File No.: 2026-394

Record of all communications from the three specified City of Vancouver Engineering staff regarding a temporary plaza at 17th Avenue East and Fraser Street. Date range: January 1, 2026 to March 7, 2026.

From: "Magnusson, Rachel" <Rachel.Magnusson@vancouver.ca>
To: "Timms, Ryan" <Ryan.Timms@vancouver.ca>
Date: 3/5/2026 10:34:00 AM
Subject: RE: Fraser-17th - New TMP Approach - 2026-03-04

Fraser-17th Temporary TMP Plaza

*Rain's quick mark-up of what may be possible post-VFRS consultation. Green hatch is proposed footprint, yellow hatch is potential footprint expansion, and red line is permeable boundary required by VFRS for outrigger deployment.

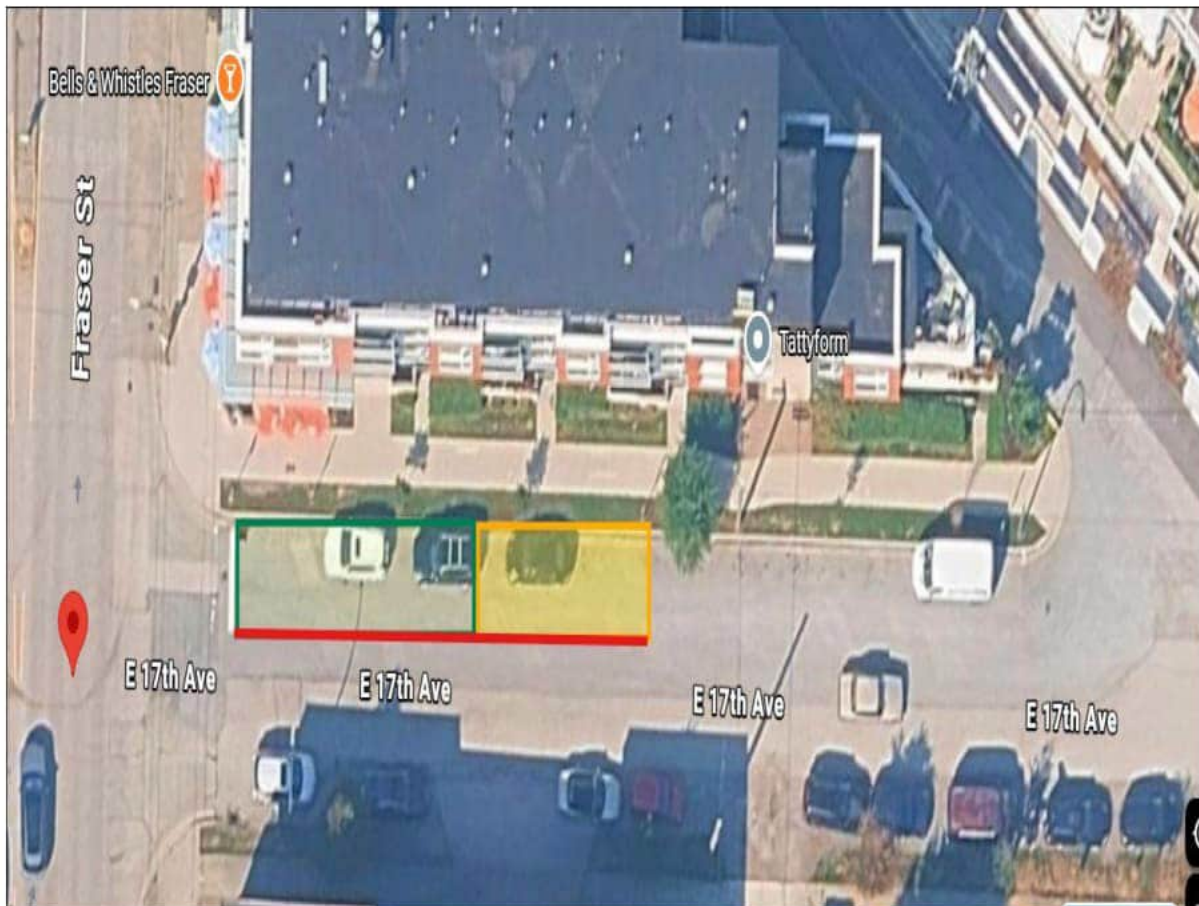
1. Greg

- Concern re: hostile vehicle mitigation and overall safety approach.
- Flagged TMP maintenance responsibilities and need to manage City liability while keeping the site safe.
- Risk of traffic equipment being removed.
- More ideal to retain Form 1 due to regulatory signage requirements. Otherwise

- can strive to strap signs to existing sign posts / saddle mounts / block piers.
 - Flagged strata/residents with mobility issues requiring vehicle access when removing curbside parking.

2. Ryan
 - VPD will likely require concrete block ends and possibly additional blocks along the red line.
 - Restaurant staff cannot monitor or adjust traffic equipment – not qualified.

- VFRS has historically been flexible with FASE; consider an end-of-block TNS so Fire can pull in (e.g., extend closure across entire north-side length of 17th).

- Ryan to prepare TMP mock-ups; requires review by Chris/Winston/Rachel and upper management approval if bypassing geometric/Form 1 process.
 3. Brian
 - Site cannot be actively managed; preference for concrete blocks without delineators.

- Sign mounting options: strap to existing poles, stake in softscape, or windmaster with lock (no tripods).
 4. Rain
 - Needs confirmation whether concrete barrier + IRS bollard can proceed via TMP review.

- Greg indicated yes, if upper management signs off on proceeding without geometric/Form 1 and risk (e.g., FOI) is accepted.
 - Pursue Ryan's suggested approach with VFRS (ie. TNS at end-of-block).

- Use Fraser-48th and Dunbar-27th as templates; consider incorporating boundary treatment used at Main-3rd plaza.
 5. Belinda
 - Suggested full block closure from Fraser St to driveway; unfortunately not supported by VFRS.

- Clarify whether FASE is permitting alcohol (not currently considered part of alcohol consumption site).
 - Duchess (Adanac-Vernon) will require similar TMP approach; finalize Fraser-17 approach first and replicate as appropriate.
